Access Compliance Report Public Rights-of-Way (Curb Ramps)

Main Street: BEACH_BLVD Cross Street: BOLSA_AVE Location: SW

ADA ID: RPRK210929153702 Ramp Type: Type 1 - Perpendicular Diagonal Initial Pass/Fail: Pass Overall Compliance: No Severity Score: 8

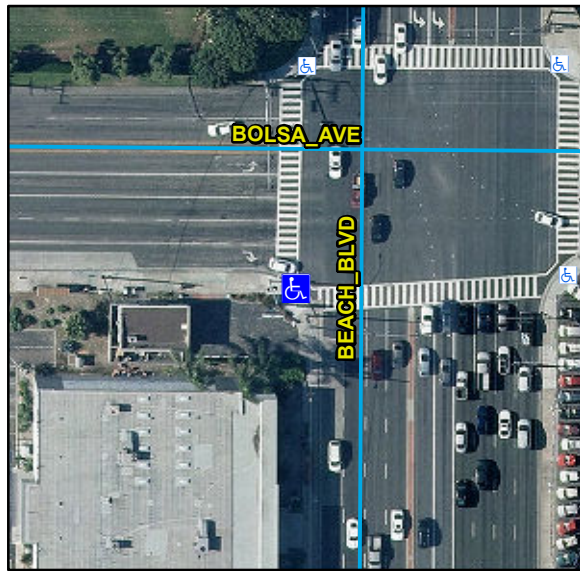
Remove & Replace Landing. Gutter Ponding Observed.

N/A	Ramp Inside Crosswalk 1	N/A	Yes	Ramp Inside Crosswalk 2	N/A
	Crossing 1 Slope (%)	9.9		Crossing 2 Slope (%)	2.4
	Crossing 1 Cross Slope (%)	1.6		Crossing 2 Cross Slope (%)	1.9
No	Gutter Ponding	Yes	Yes	Curb Slope	1.1
Yes	Gutter Lip Height (in)	0		Road Run Slope (%)	1.1
Yes	Gutter Run Slope (%)	1.9		Road Cross Slope (%)	9.2
Yes	Gutter Cross Slope (%)	0.1			
Yes	Overall Surface Condition: Acceptable		Yes	Perp Joint Present	Yes
	Cross Gutter Present?	No		Spandrel Present?	No
	Replace Cross Gutter?	No		Replace Spandrel?	No

Possible Solutions:

R304.2.1, R304.2.2-Perp, R304.3.2-Para, R302.7, STD 1115
